All Issue Details

Project: SPX19432

Order#: 1306986-iRW **Part#:** TRELLIS

Sunnyvale, CA

Screenshot.png

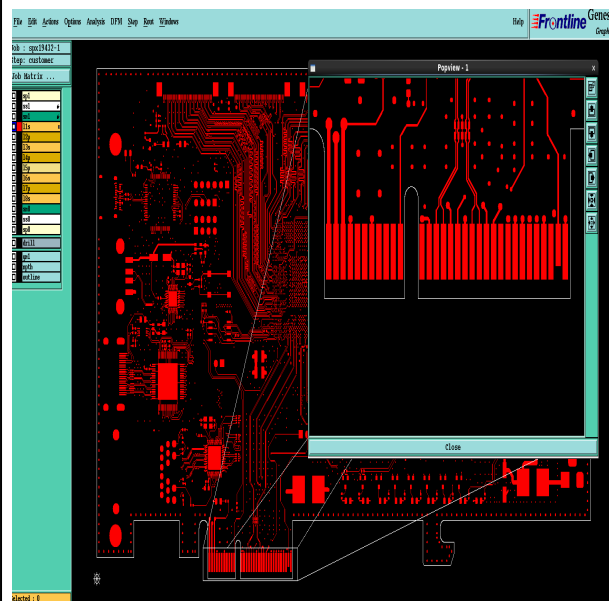
While performing DFM validation, we observed finger like features are present but web Spec calls for gold finger as "None". Please confirm whether you require hard gold plating for the fingers or you want the whole board to be ENIG finish. FYI: In case of hard gold plating requirement for the fingers, we need to revise the quote for which our sales team will be in touch with you.

No gold plating is required. Whole board ENIG.

top maks.png

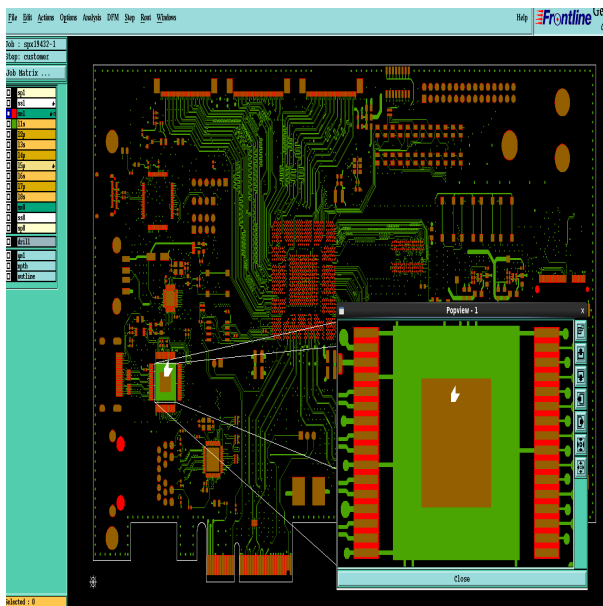
While DFM validation, we observed partial mask opening for rectangular pad at one location in top mask layer. Find Enclosed snap shot for your quick reference. Can we provide complete mask opening at this location(Pad size+4Mils) OR would you like us to proceed as is? Please confirm.

Provide complete mask opening at this location(Pad size+4Mils).

bottom layer.png

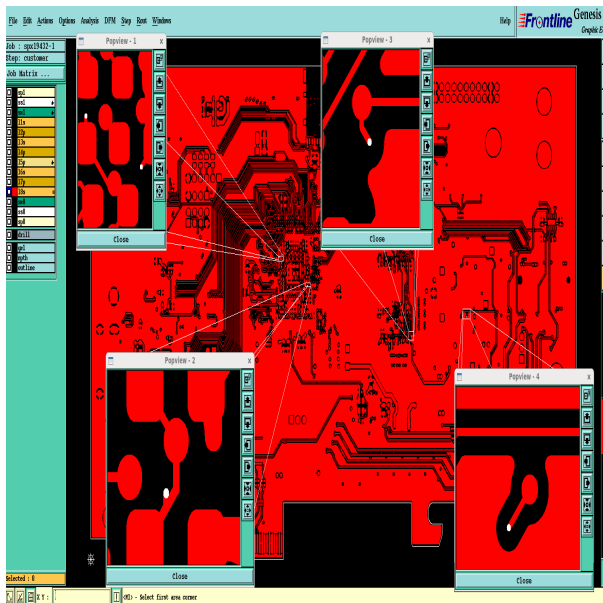
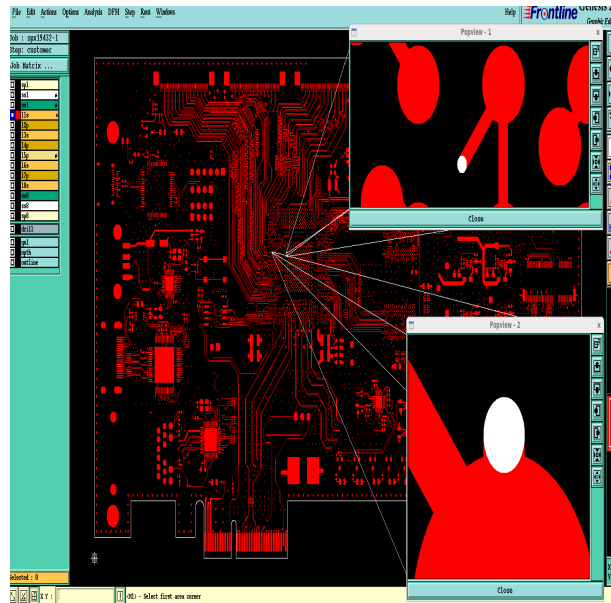
While performing DFM validation on your order, we observed few un-terminated traces (stubs) in top and bottom layer. Please confirm whether this is by design or else advise. Attached snap shot for your quick reference.

Can we proceed as is? Please confirm.

I was just looking into this. Please proceed as is.

bottom mask.png

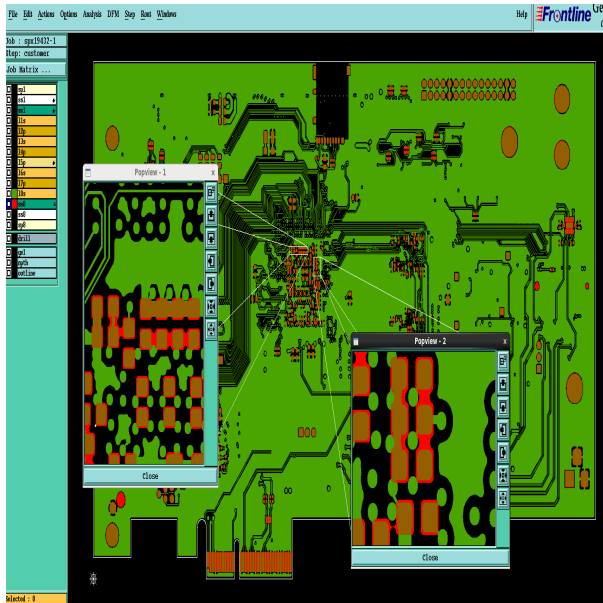
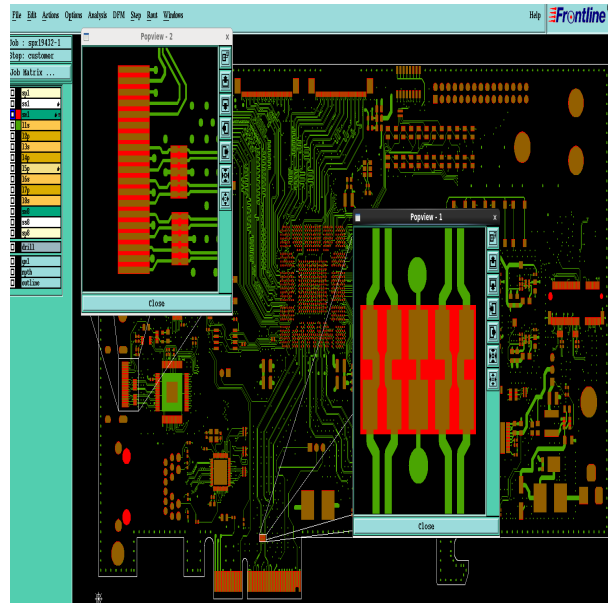
While performing DFM validation we observed that, Gang mask opening is provided in both solder mask layer. Find attached snap shot for your quick reference. This job is going to be assembled at our facility and we prefer individual mask opening. Please allow us to remove Gang relief and go ahead with individual mask opening. Please confirm.

Ok, confirmed.

bottom layer.png

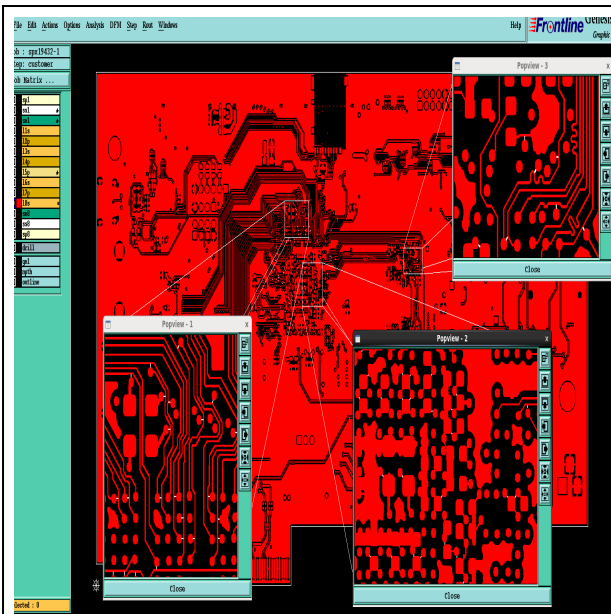
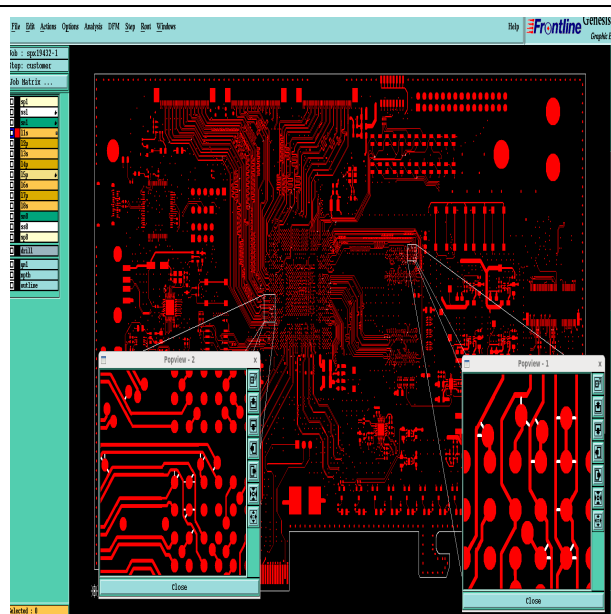
While performing DFM validation on your order we observed that 3.042 mil spacing on your design (top and bottom layer) but web spec calls 4 mil spacing. Also less than 4Mils spacing is not qualified for Web orders. This may required custom quote for which our sales team will get in touch with you.

Ok, please proceed with custom quote.

Confirmed.

j1.JPG

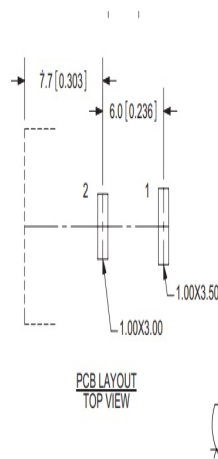
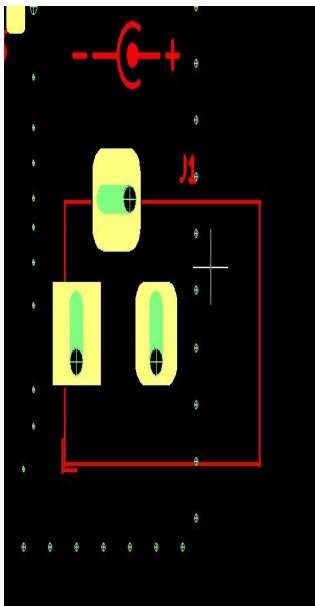
DFA checks of your files show a footprint mismatch of components J1 (Line Item# 29) [MPN: PJ-037A] in GERBER files w.r.t. mechanical dimensions as per datasheet. As shown in image, Gerber footprint is not matching with recommended land pattern. Kindly provide an alternate part# for this or advise if we need to make component DNI.

PerIST137106 that is going to be manually placed.

We will place it on available footprint.

160832-stubs on layer4.png

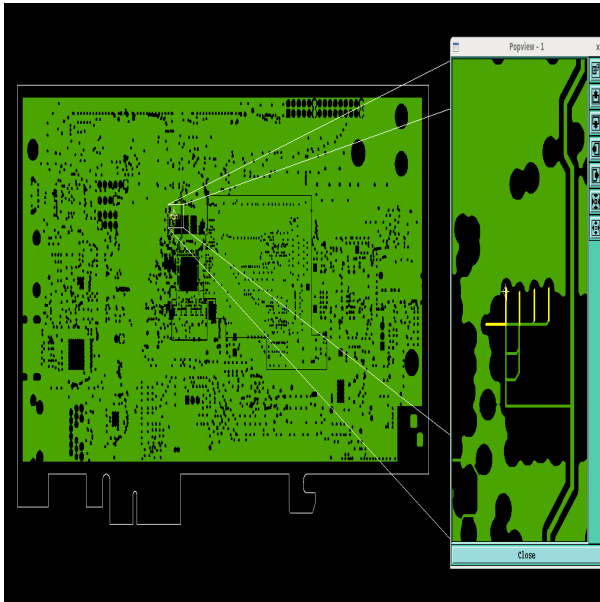
While performing DRC on your order, we observed stubs(Un-terminated traces) on inner layer4 at 5 locations. Please confirm can we proceed as is or else advise. Screen shot attached for your reference

Proceed.

D27.jpg

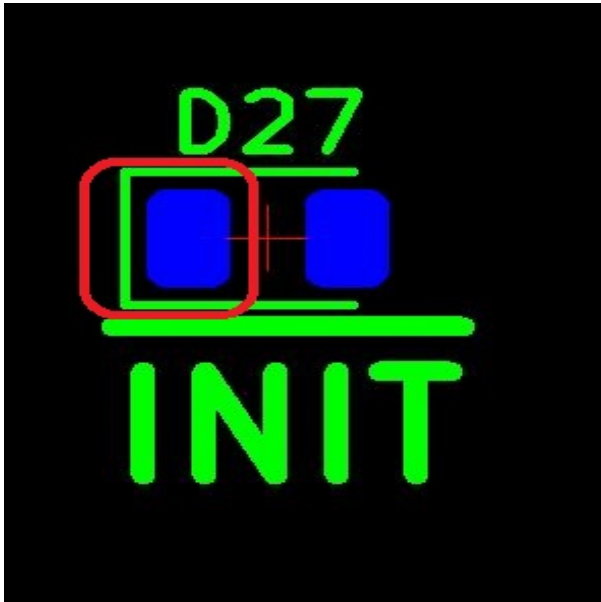
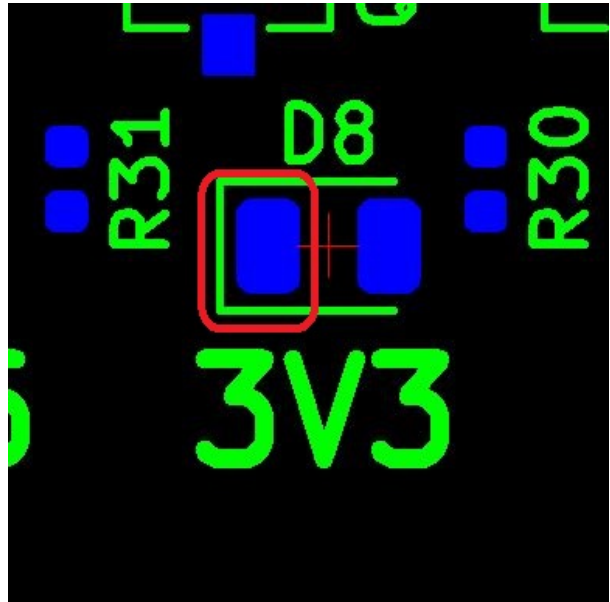
We need you to advise if the marked pad of components mentioned below is cathode: D27 (Line Item# 22) [MPN: LH R974-LP-1] D8,D2,D26,D4,D5,D6,D7,D9,D10,D11,D12,D13 (Line Item# 24) [MPN: LG R971-KN-1]

D8, D2, D26, D4, D5, D6, D7, D9, D10, D11, D12, D13 cathode is on left.

D27 Cathode is on the left, as circled.

X1.jpg

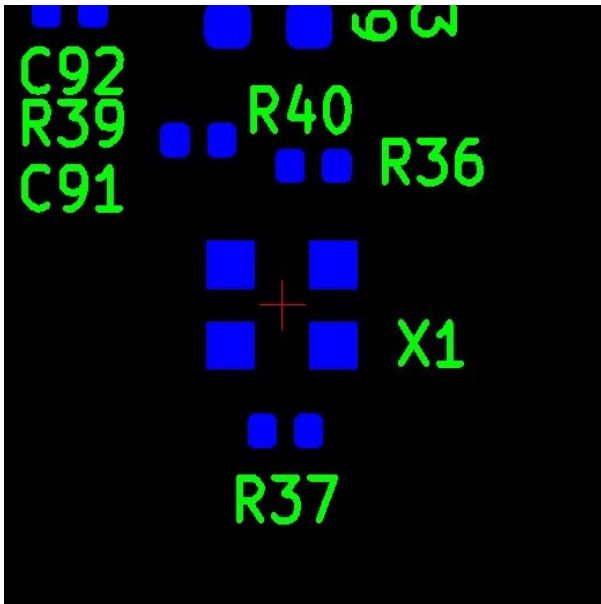
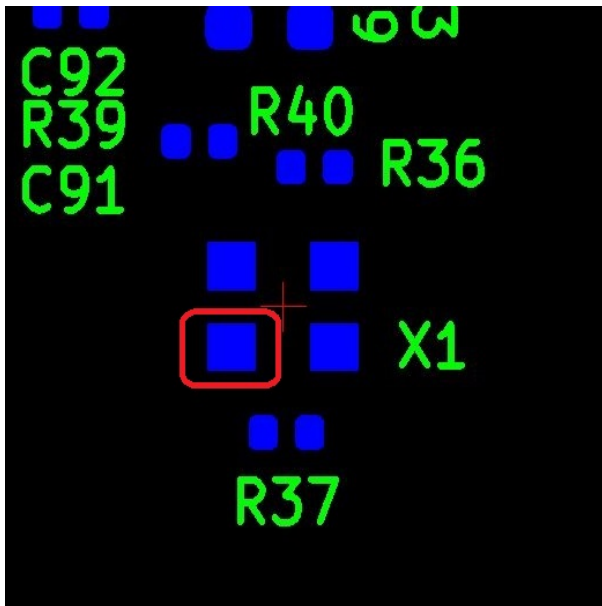
We need you to advise for the PIN1 marking for below mentioned components as it is missing in silkscreen layer. X1 (Line Item# 95) [MPN: ASE-12.000MHZ-LC-T]

X1 Pin 1 is bottom left in your image.

As per your reply we have considered below marked pad as pin1.

Capture.JPG

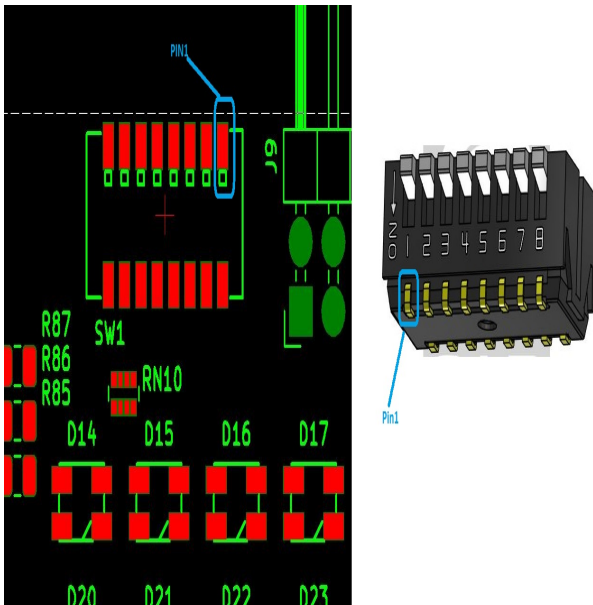
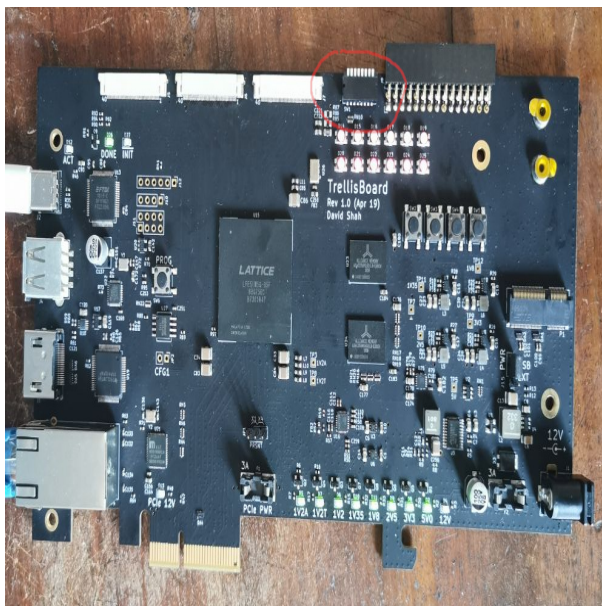
For the DFA checks, we need you to advise if the marked pad of components mentioned below is pin-1: SW1 (Line Item# 73) [MPN: CHP-081TA]

See attached photo of board. It looks like you have pin one in opposite corner in your diagram.
